**Product Change Notification PCN\_BUR\_00201**

Subject: new screws for our Eaton's Bussmann series Insulated Metal Gripping Lugs NH fuse links

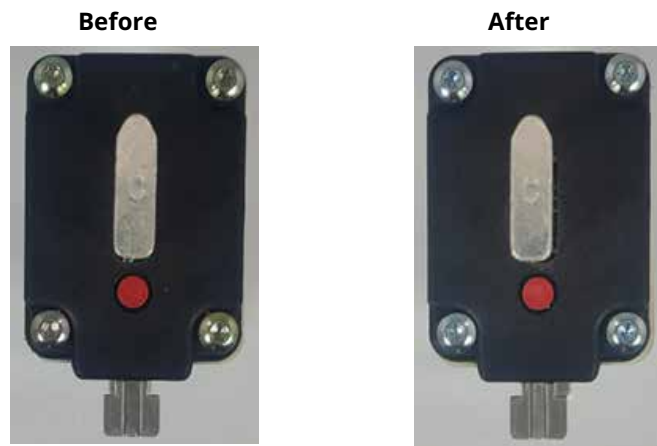
We would like to inform you of a design change to the body screws used on some of its IMGL (Insulated Metal Gripping Lug) Eaton's Bussmann series NH fuses in size NH1 and NH02. The passivation/plating colour of the body screws of the affected fuses will now be white, see images below.
